Attachment B

Proposed coverage per Verizon's Maps

Map of Boulder Creek with simulations of Verizon's map on page 35 and 38 of the staff report

Verizon's map from page 35 of the staff report

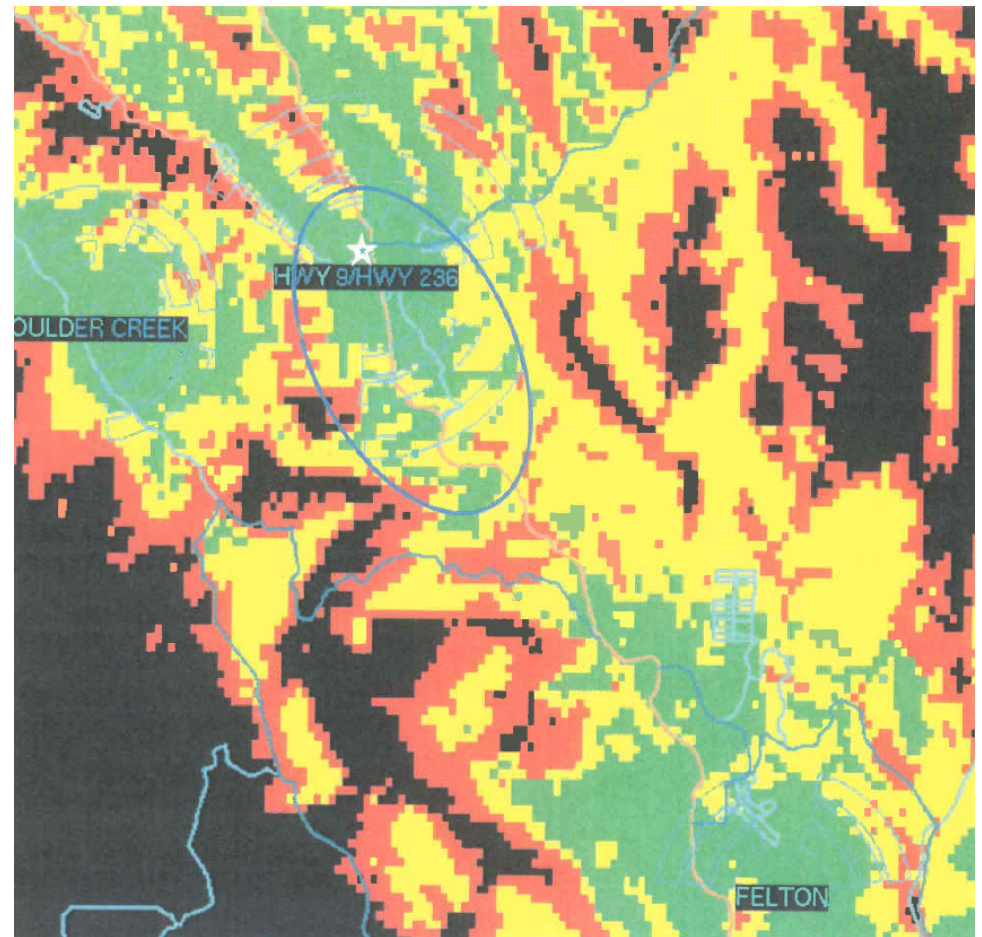
Verizon's maps have no scale and don't show any streets besides the main highways, even the highways are not labeled, making it very hard for the general public to understand their meaning and what they are showing. They don't even label where Boulder Creek or Brookdale are. Also it only shows the coverage objective, it does not tell us the strength of the coverage in each area and how the signal will be affected by terrain and other factors.

We formally request that Verizon provides maps that have a scale, show streets and highways with labels, label where Boulder Creek and Brookdale are, and show the coverage of the proposed tower with the strength of the signal clearly labeled, as well as how the terrain and other factors will affect the signal. These maps should also show each of their products, not just 4G.
